The Boston Garden

BOSTON PROPERTIES AND DELAWARE NORTH COMPANIES

DESIGN DEVELOPMENT SUBMISSION TO **BOSTON REDEVELOPMENT AUTHORITY**

FEEDBACK FROM PREVIOUS BCDC PRESENTATION

ASYMMETRICAL STAIR / ESCALATOR

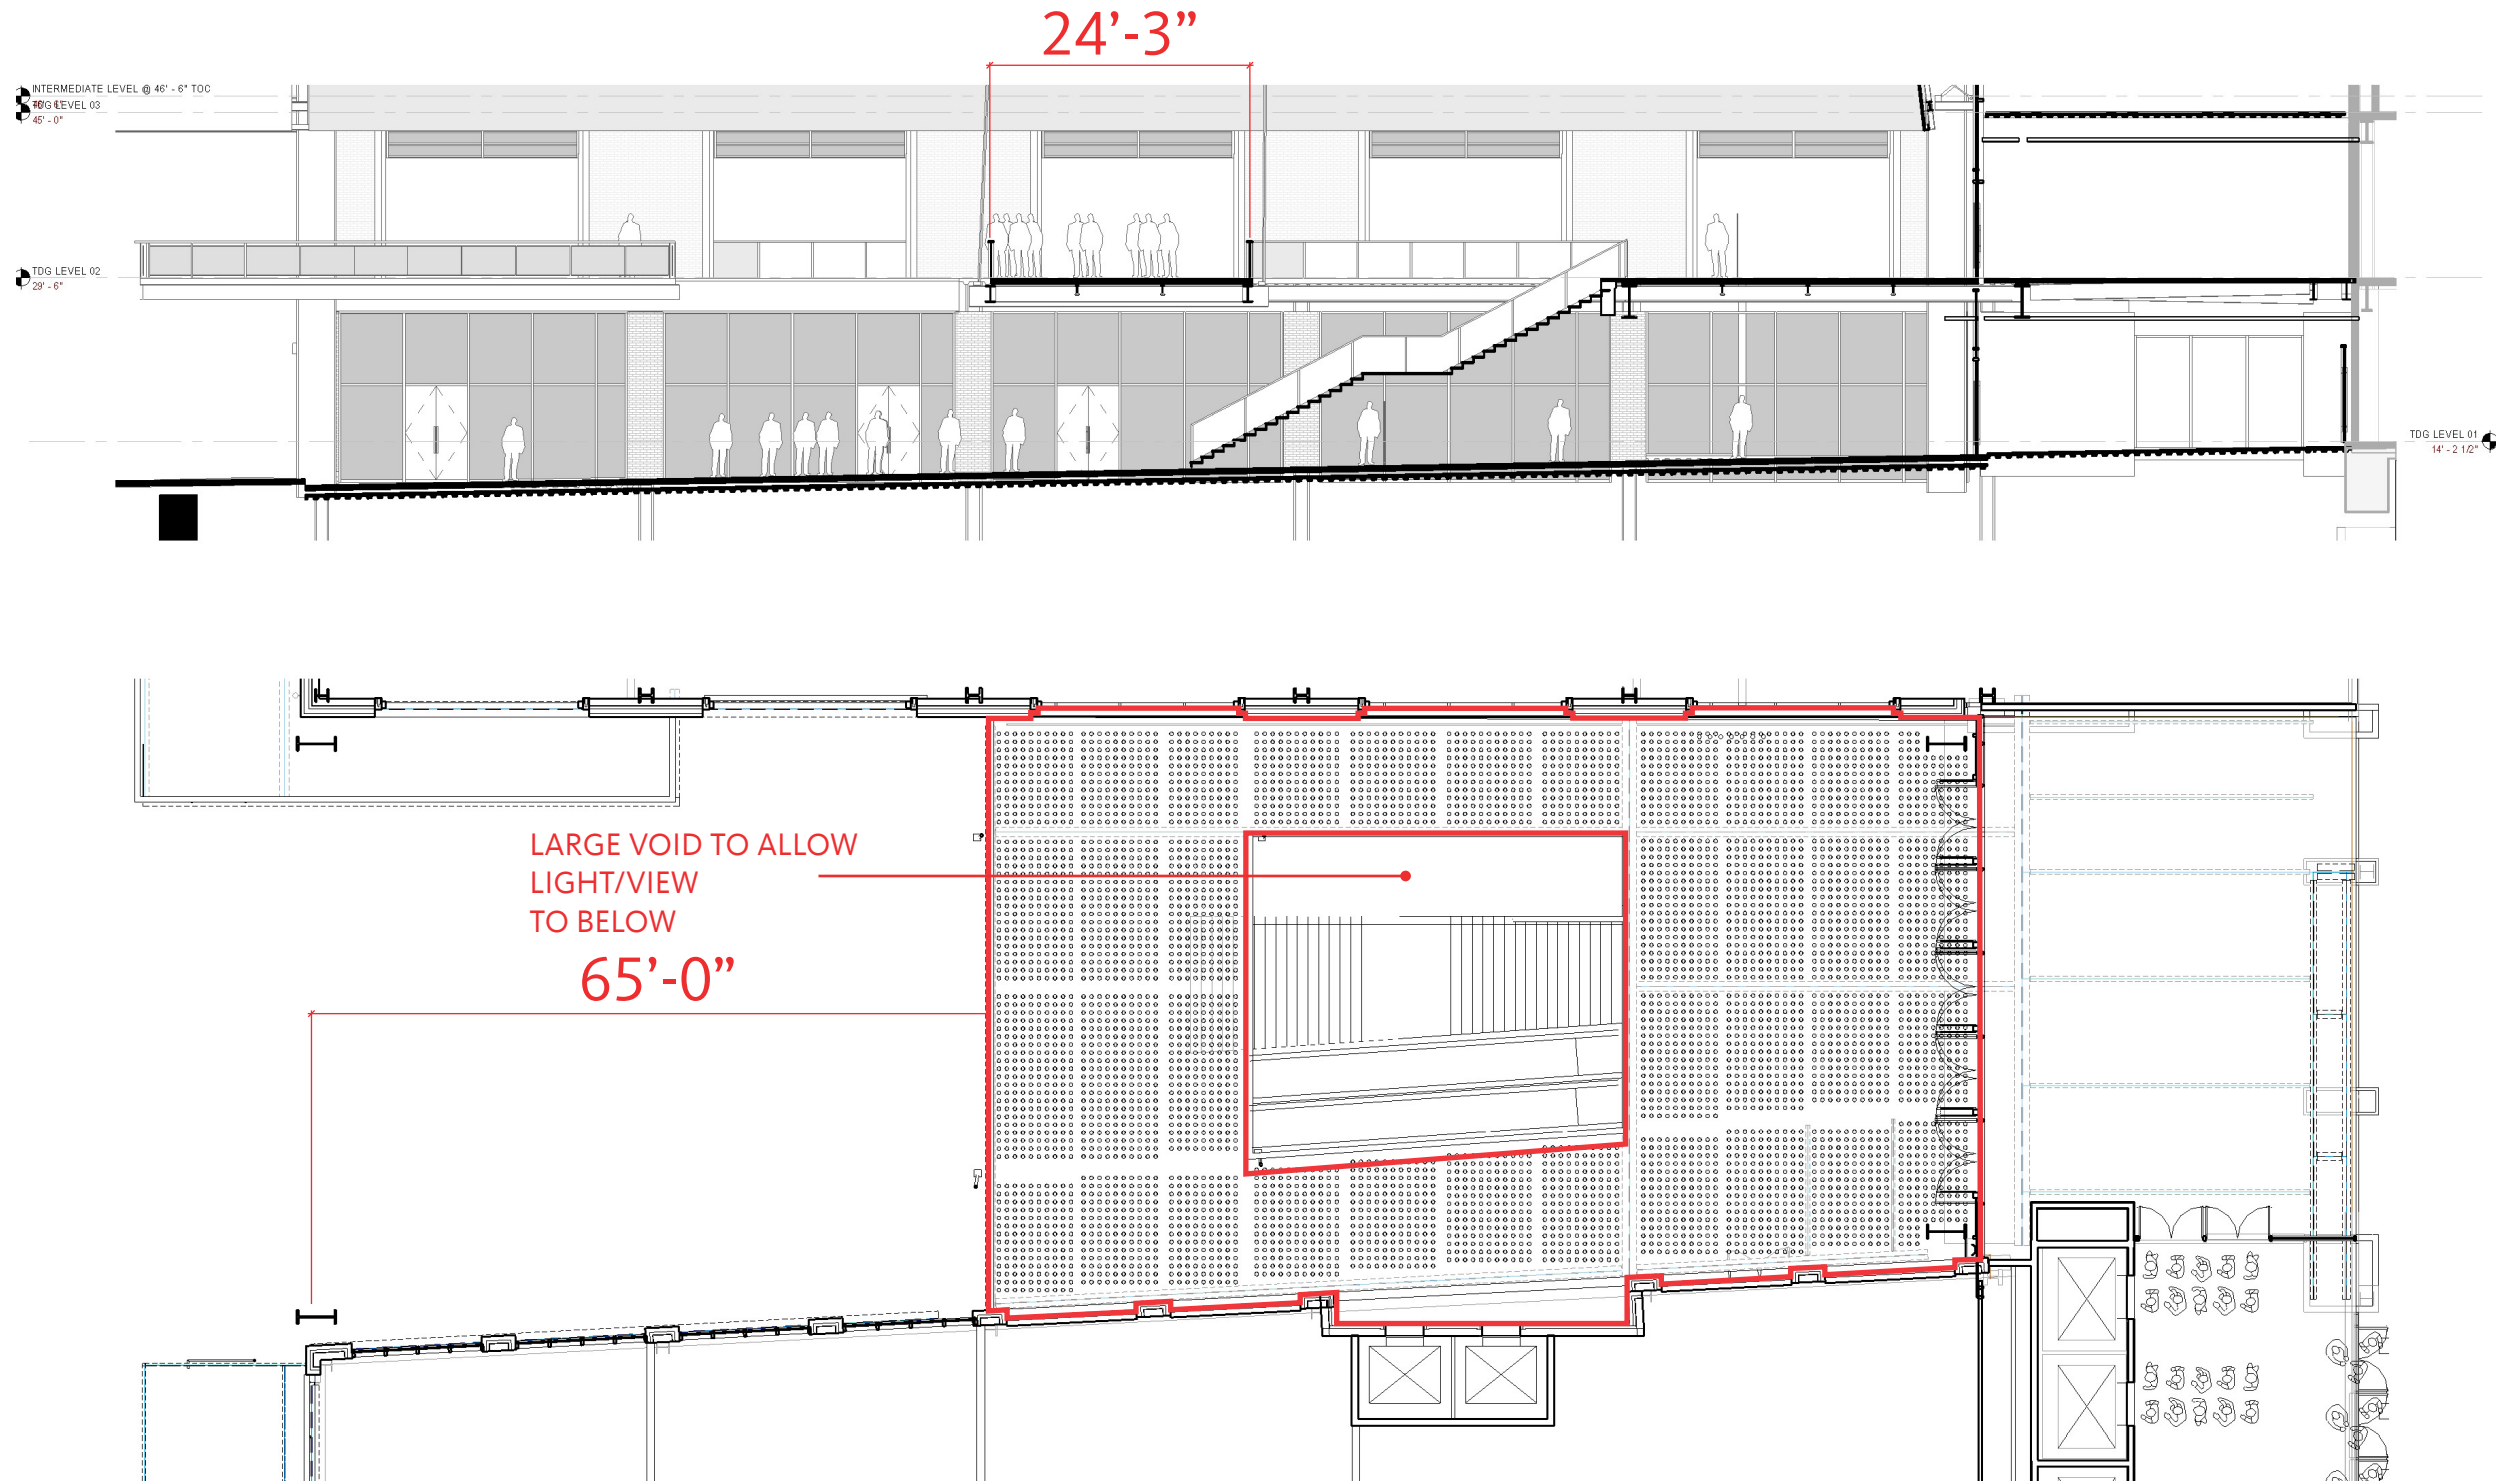
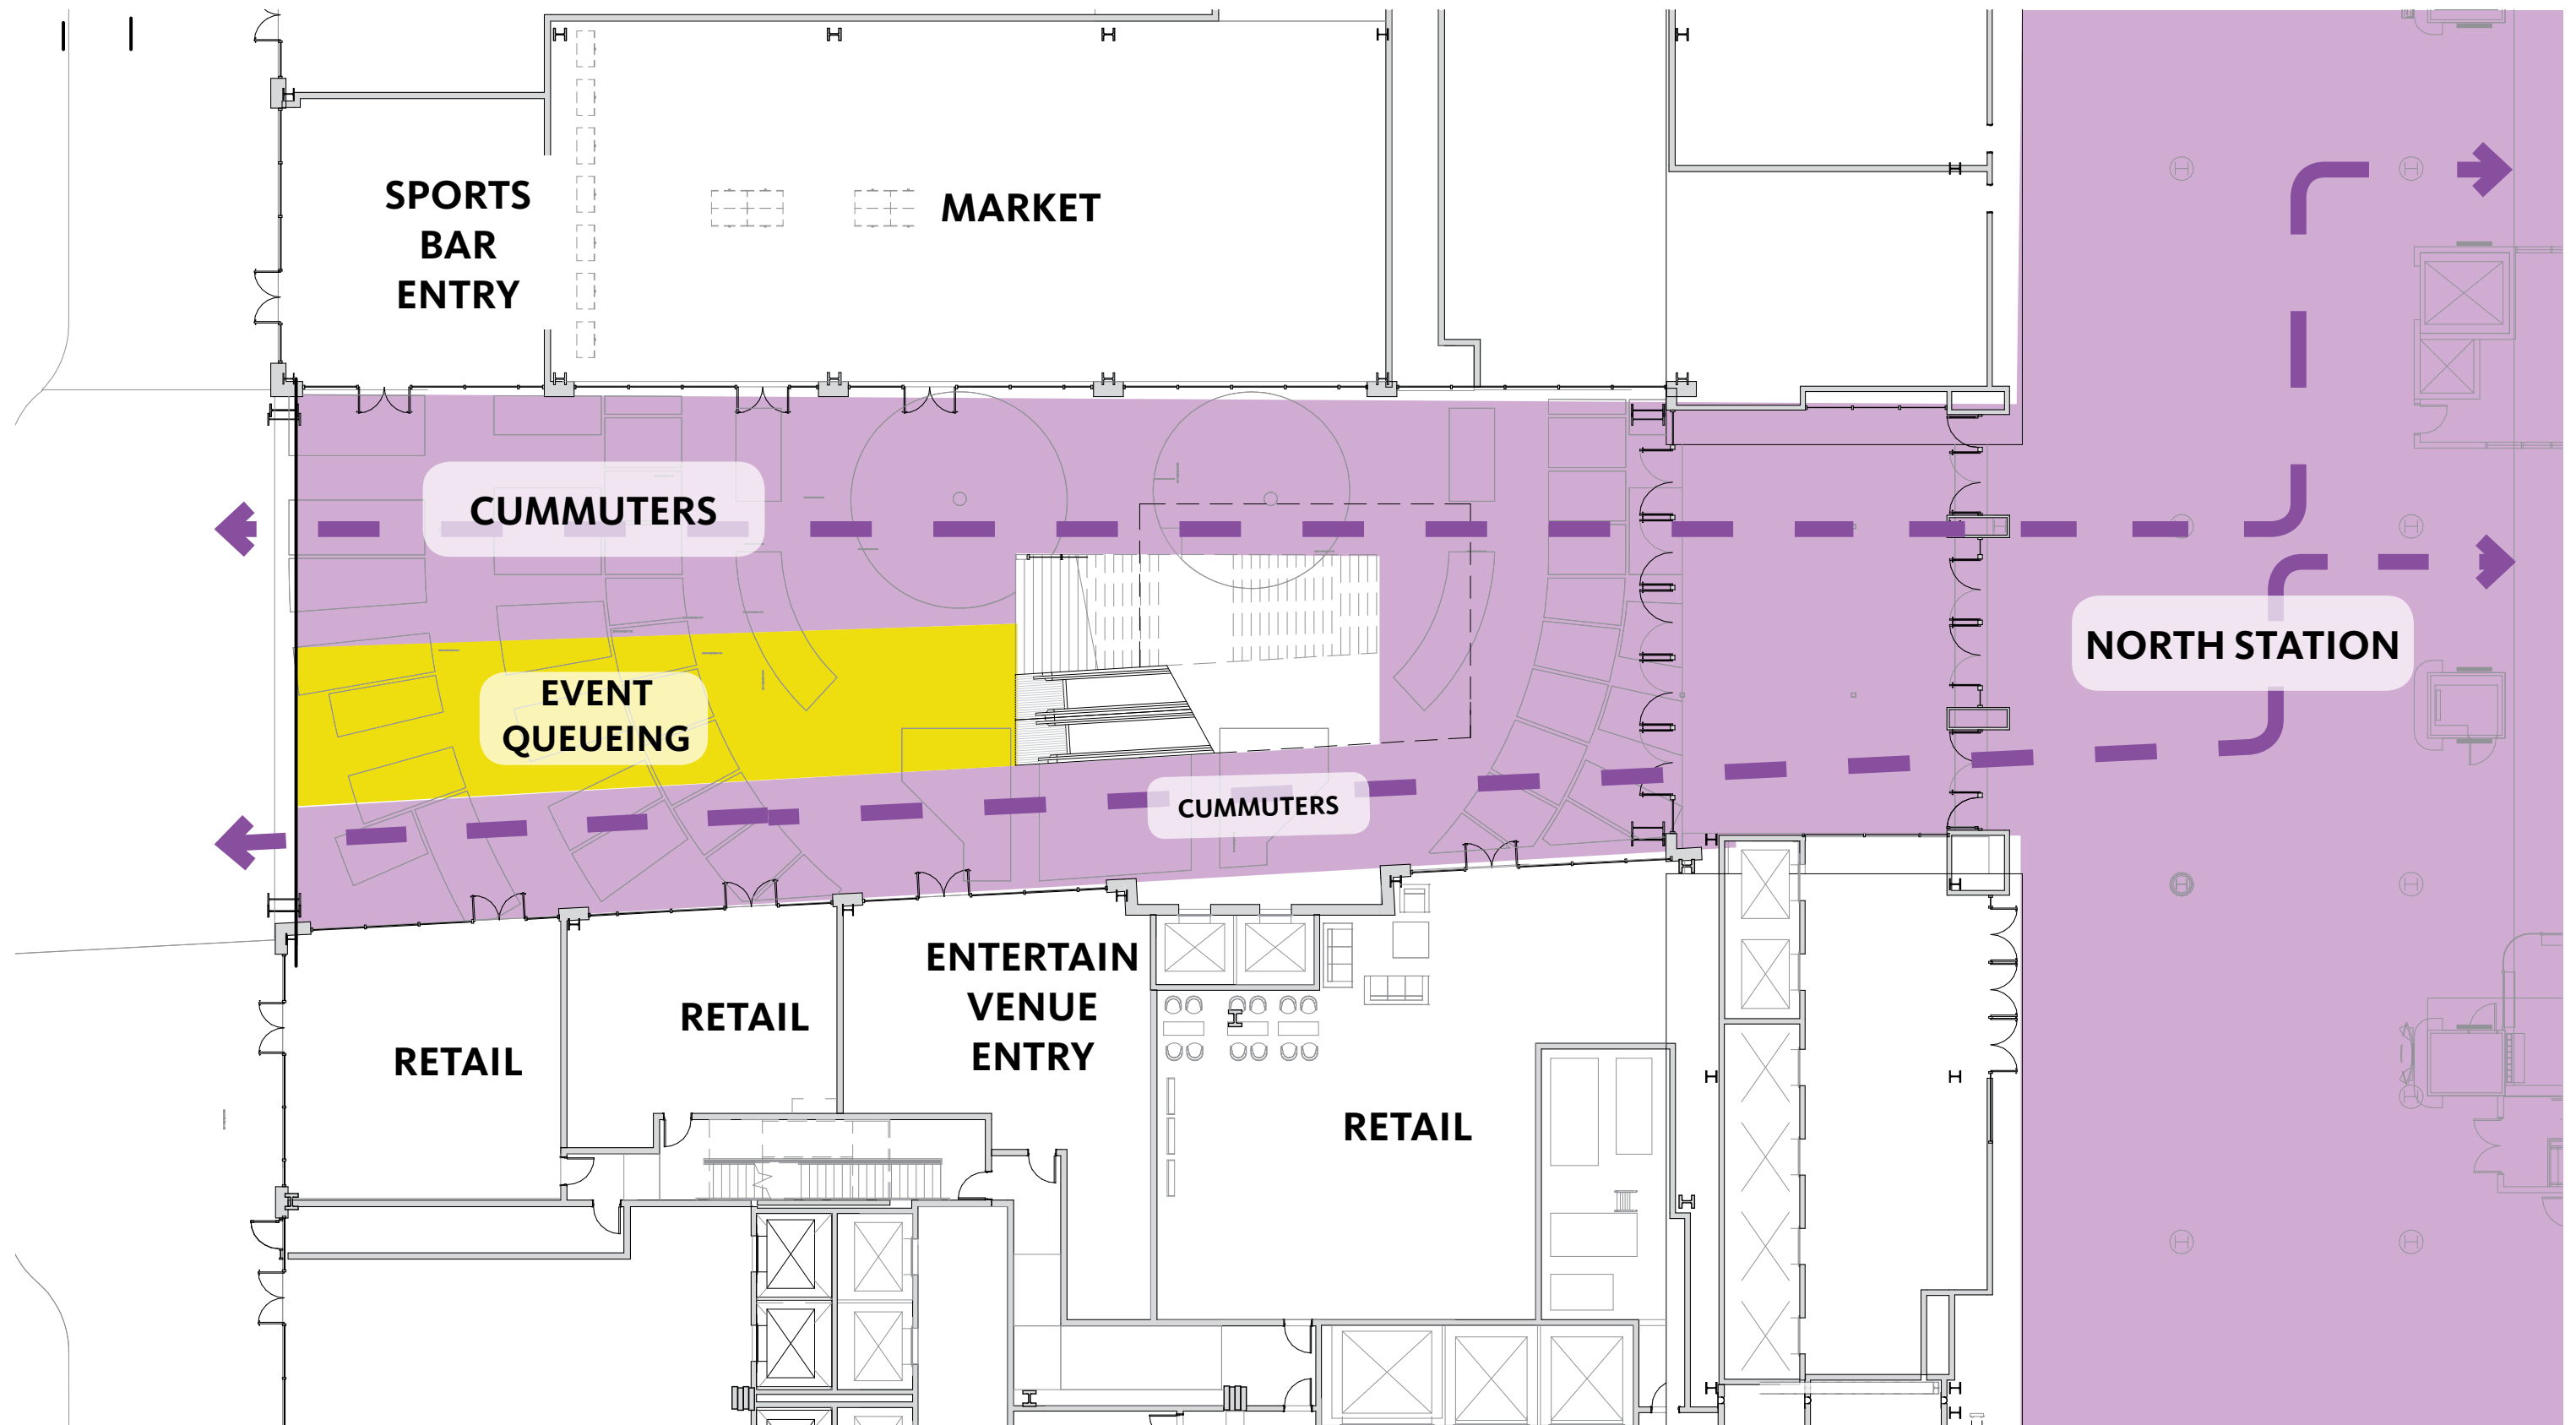
SATISFIES DRIVERS?

1. PEDESTRIAN FLOW
YES, FLOW IS BIASED ALONG WESTERN AXIS OF CHAMPIONS ROW, ALLOWING A VIEW PAST STAIR TO NORTH STATION

2. A PLACE ABOVE
YES

3. VISIBILITY AND ACCESS TO RETAIL TENANTS
YES, ALTHOUGH THERE IS GREATER SPACE AND VISIBILITY TO THE TENANTS ON THE WESTERN SIDE OF THE SPACE.
